CHINO BASIN WATERMASTER

NOTICE OF MEETING

A. 2023 RECHARGE MASTER PLAN UPDATE AND RESOLUTION NO. 2023-06

Figure 1-3. Streambed Infiltration and Managed Recharge of Stormwater in the Chino Basin, 1978-2022

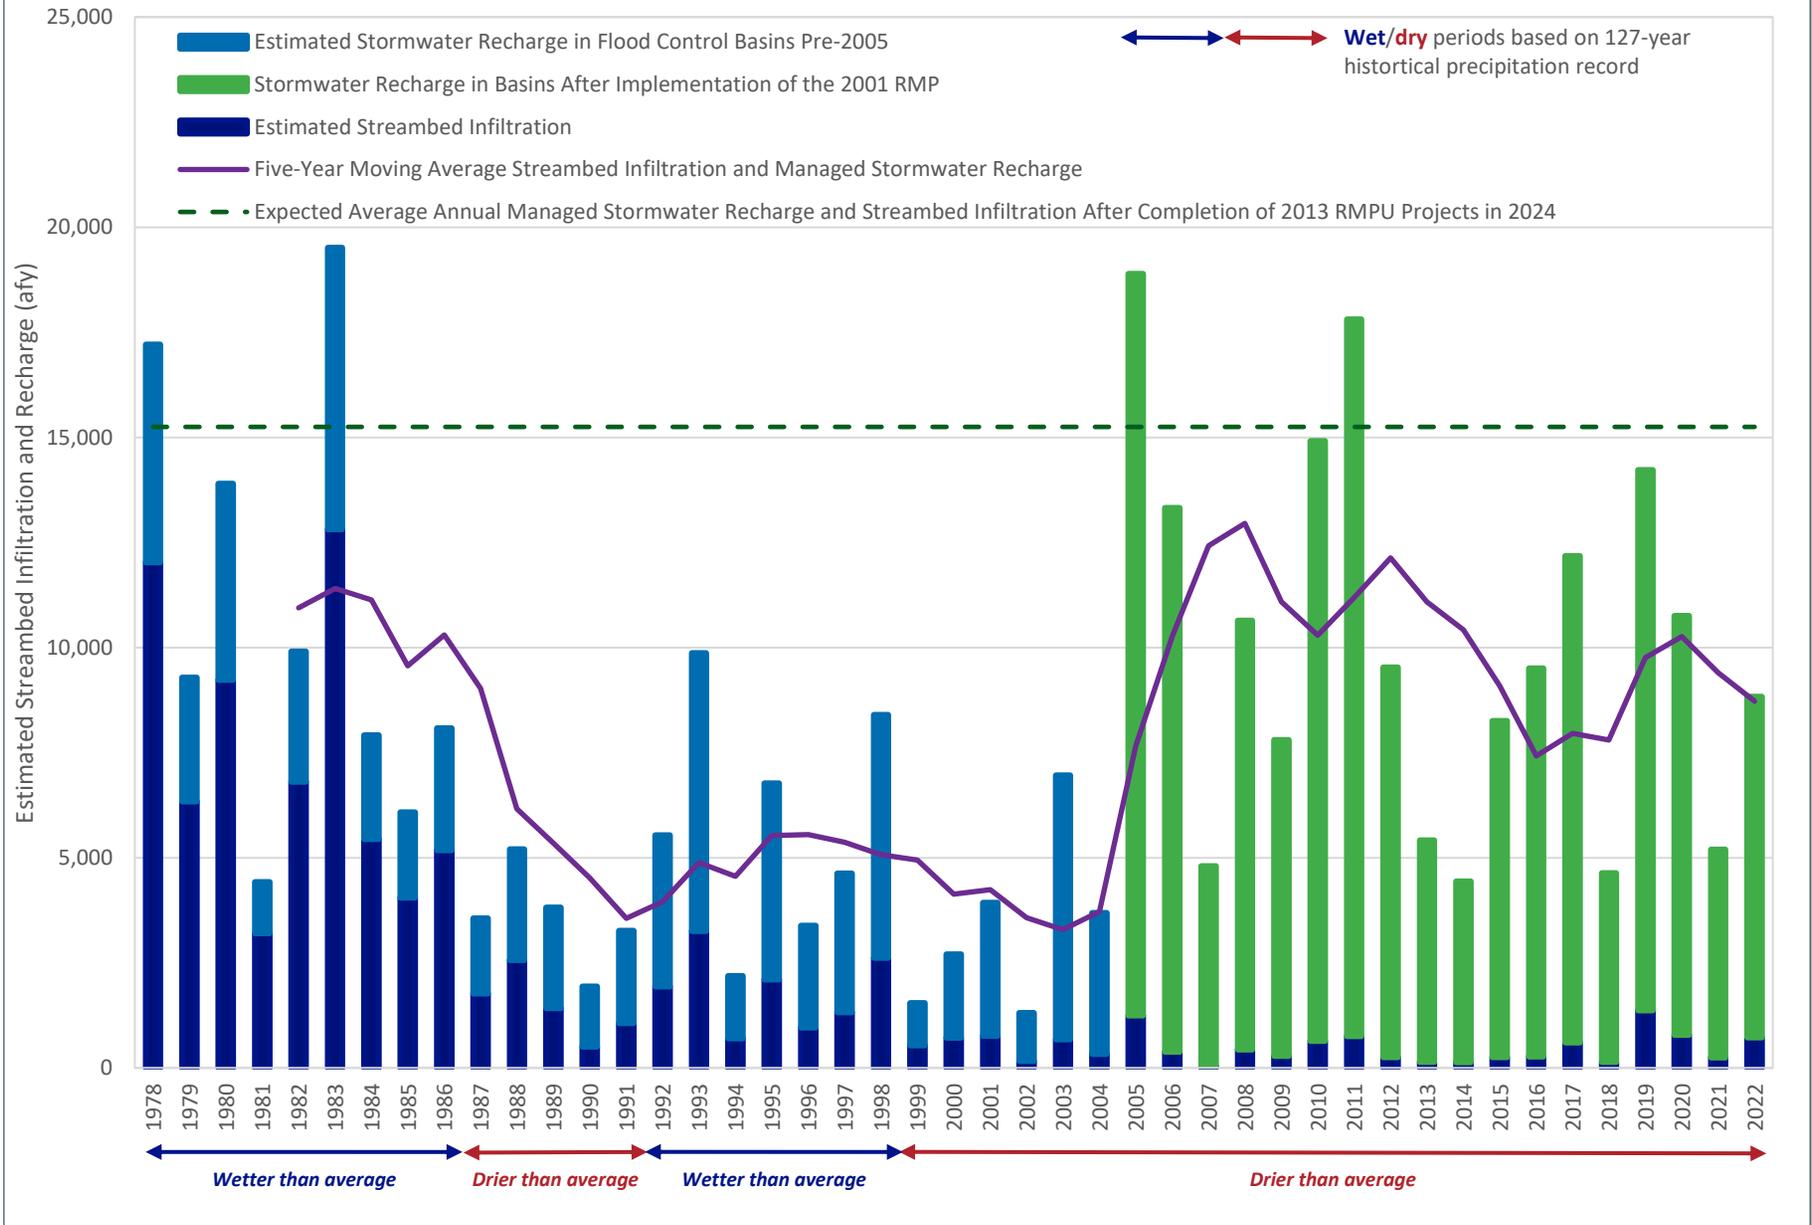
Comment 1 – Page 1-6: “Figure 1-3. Estimated Streambed Infiltration for the Santa Ana River Tributaries in the Chino Basin and New Recharge Resulting from Recharge Master Plan Implementation, 1978-2018”

Figure 1-3 has been updated to show all historical managed stormwater recharge.

Figure 3-3. Historical Groundwater Discharge from CCWF (FY 2004/05 to FY 2017/18)

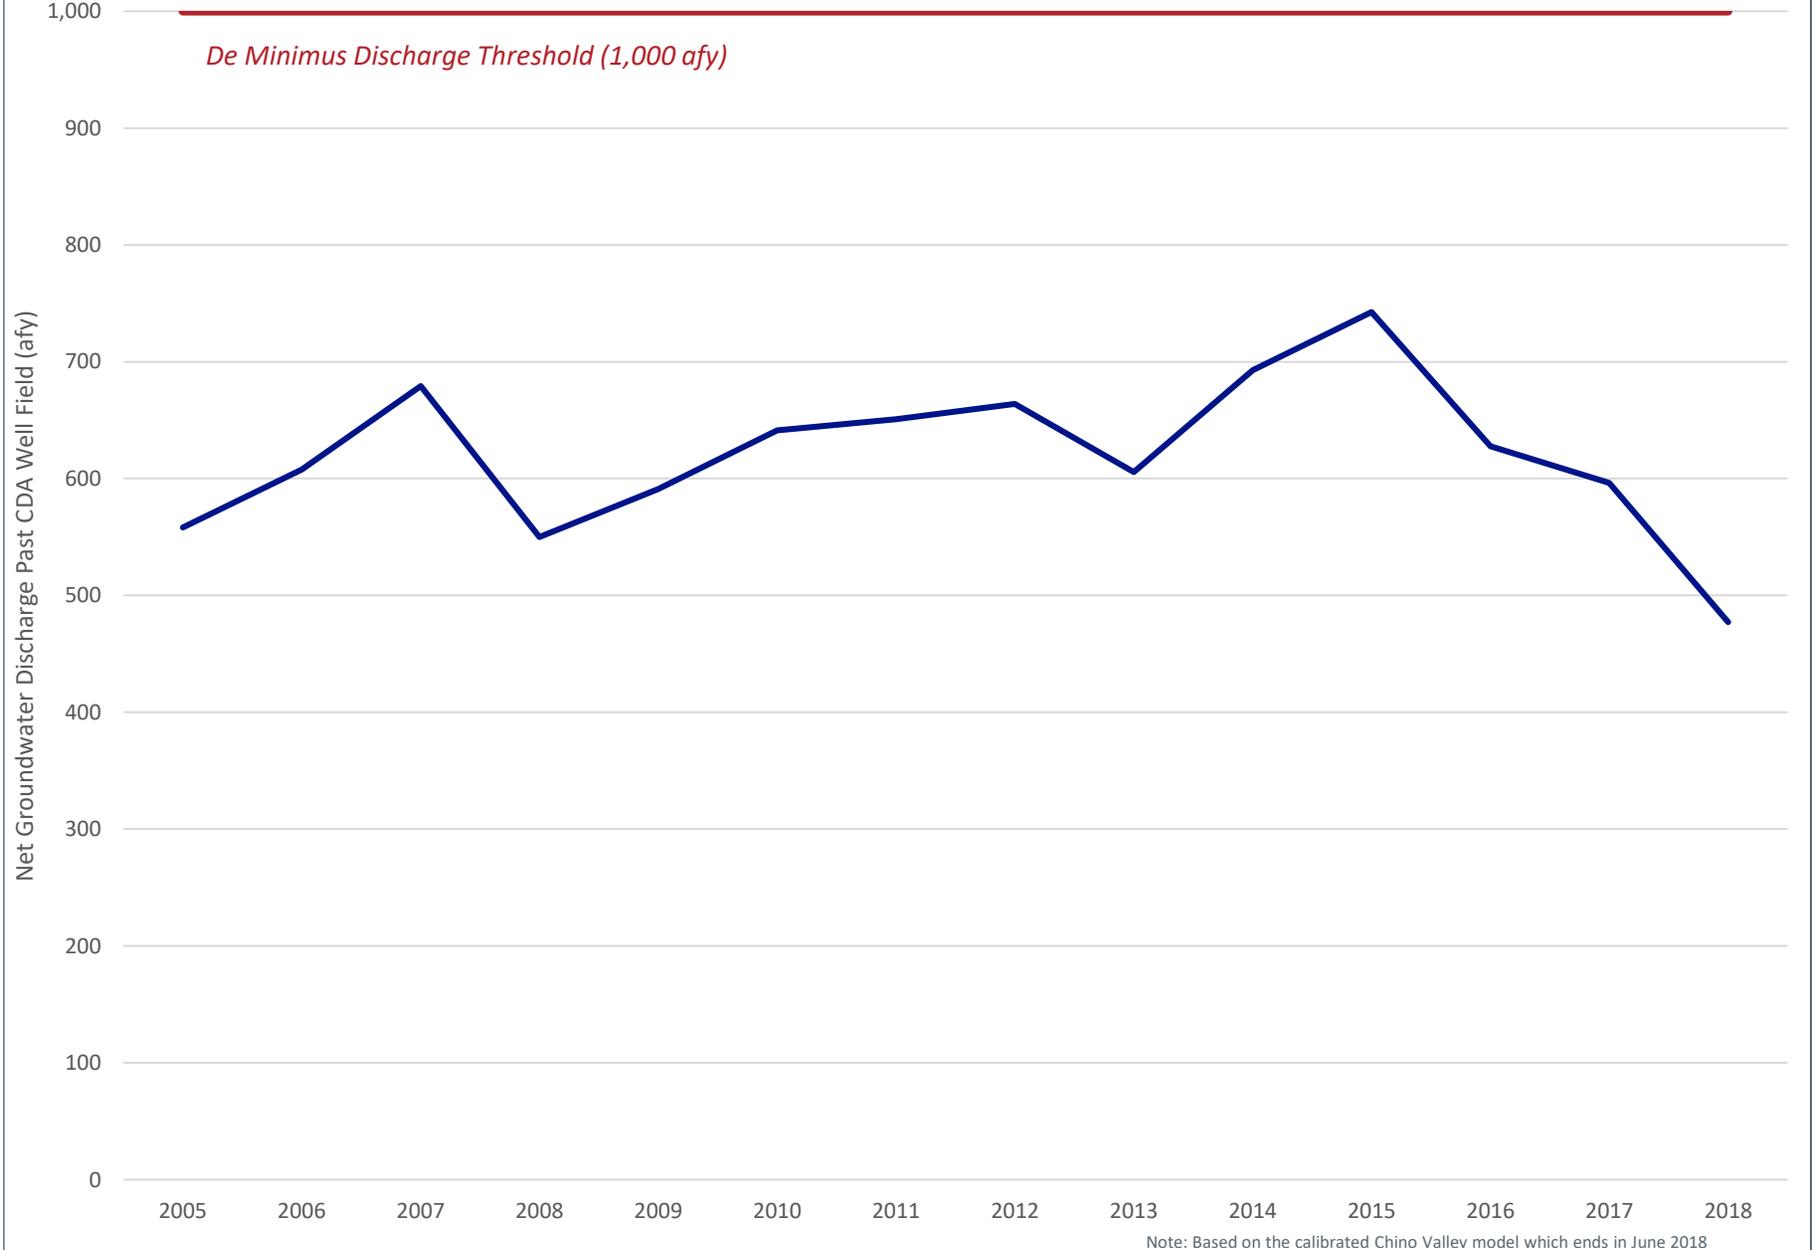
Figure 3-3 shows through 2018 and narrative states through 2023. Include note regarding model timeline.

The narrative has been updated to clarify that Figure 3-3 shows data through 2018 and that information regarding hydraulic control from 2018 to 2023 is based on the Chino Basin OBMP Maximum Benefit Annual Reports.

Figure 4-1. Comparison of Aggregate Water Demands in the Chino Basin for Various Planning Investigations

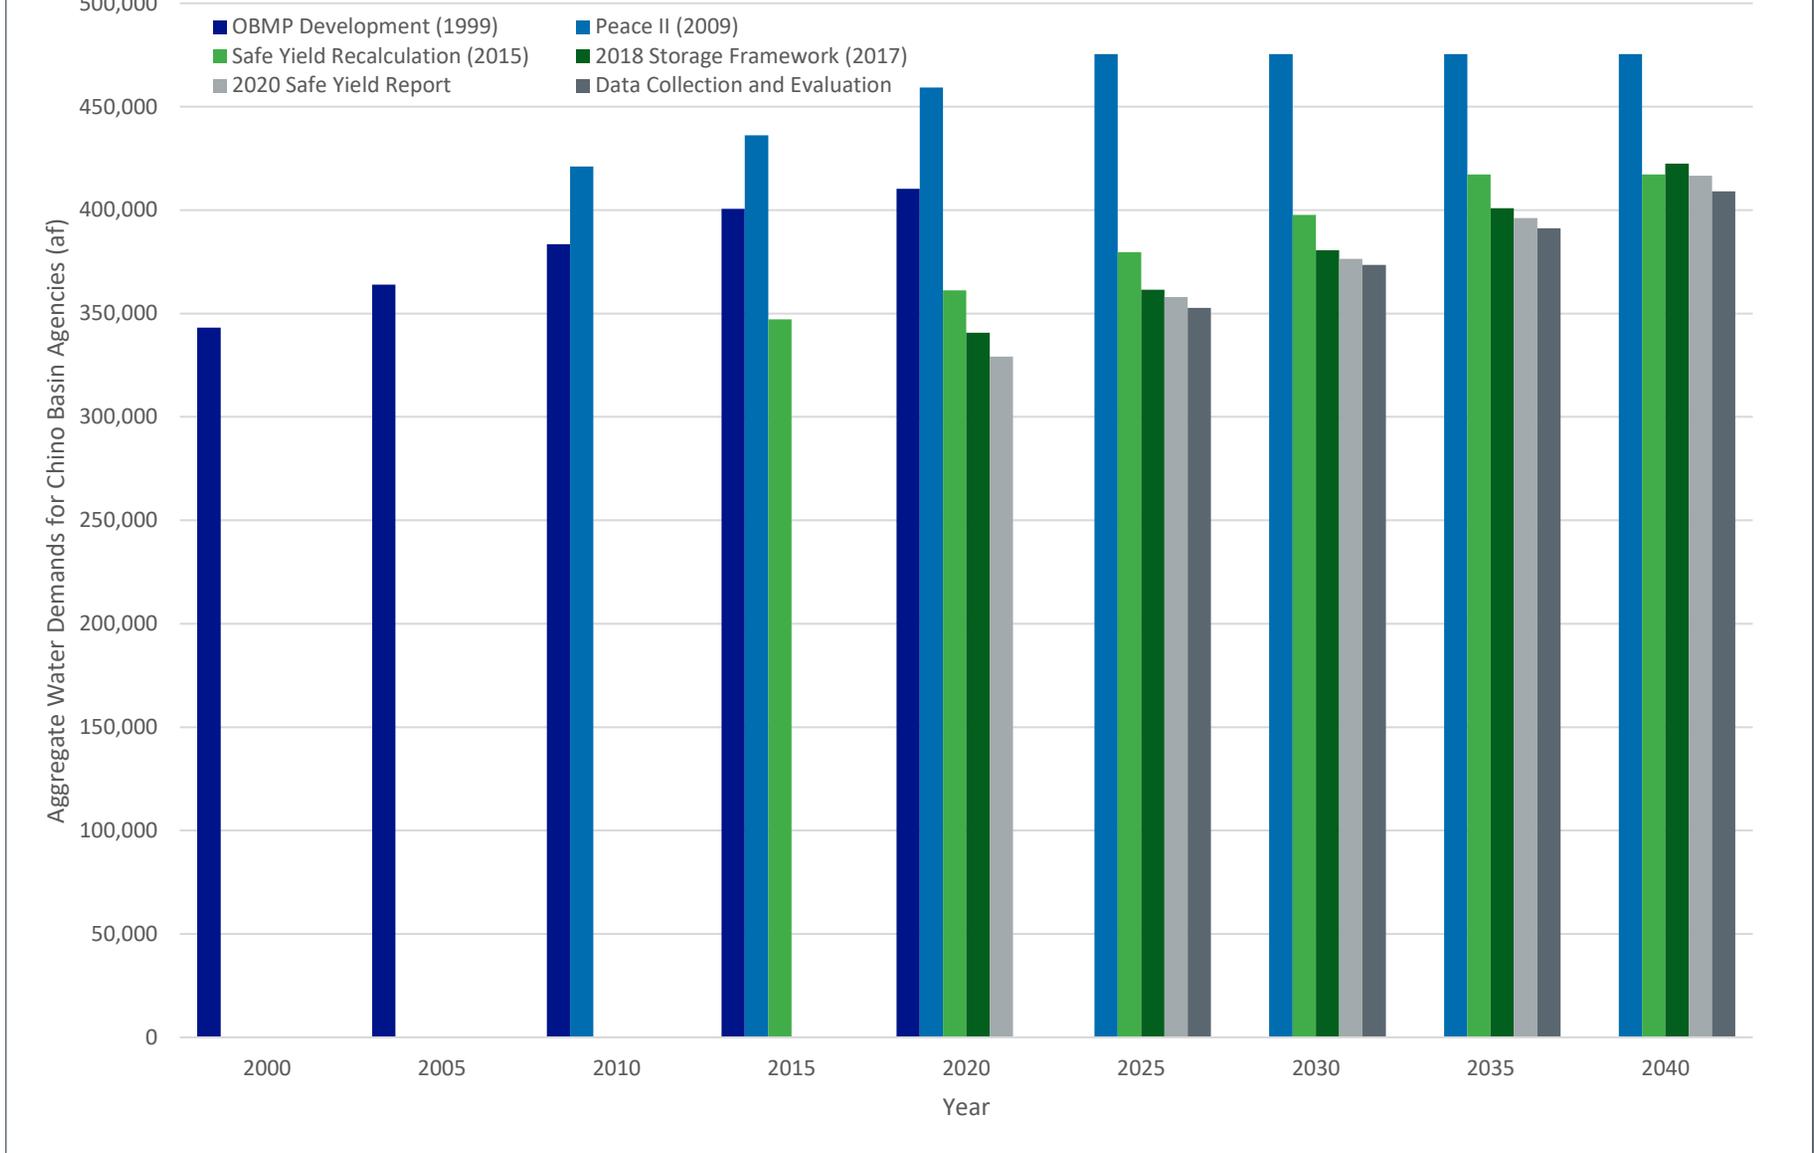
Comment 6 – Figure 4-1

Comment 11 – Figure 4-1.

Figure 4-1 was updated.

Figure 4-1 was updated.

Figure 4-3. Projected Annual Supplemental Water Replenishment and Recharge Requirements, 2023-2045

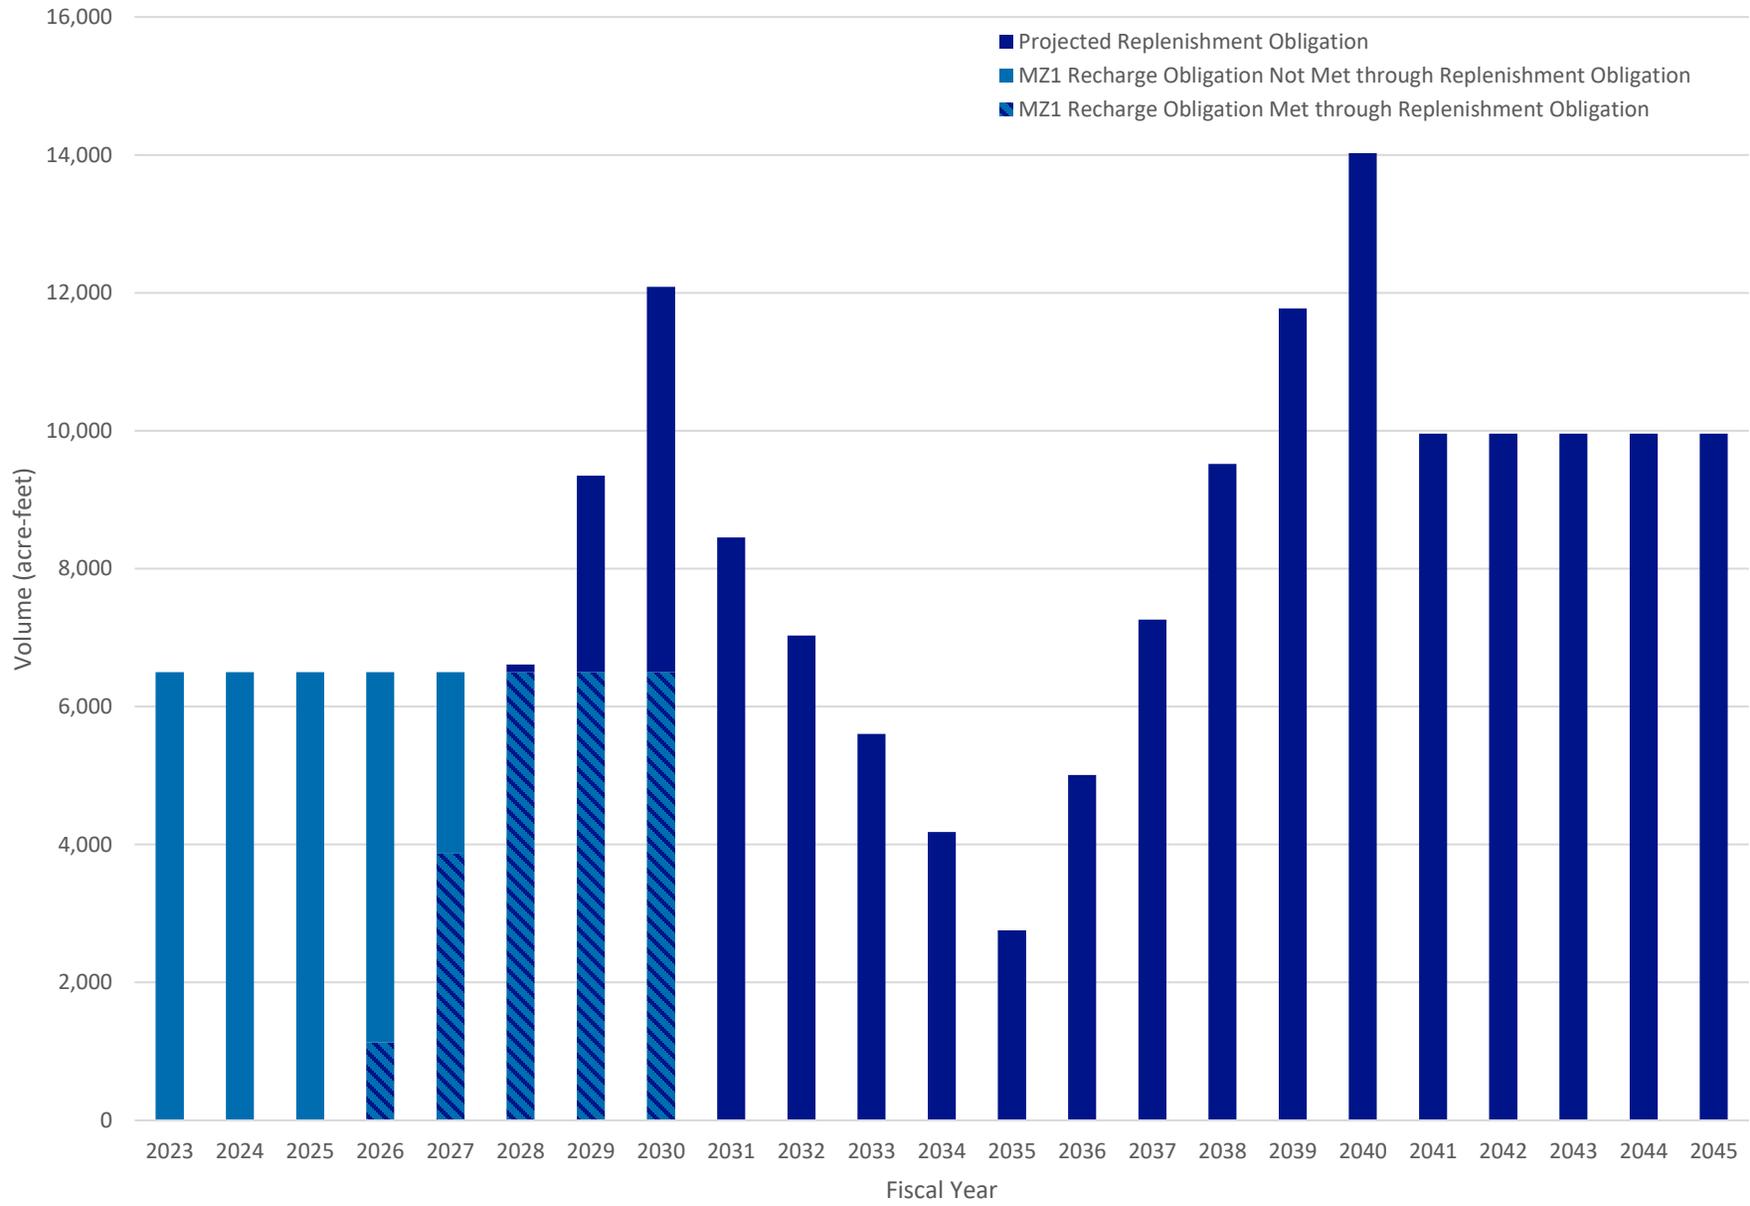
Comment 7 – Figure 4-3

Comment 13 – Page 4-5: “Figure 4-3 also shows the 6,500 afy supplemental water recharge obligation for MZ1 through 2030.”.

Figure 4-3 was updated to show that replenishment obligation is used to meet the MZ1 recharge requirement.
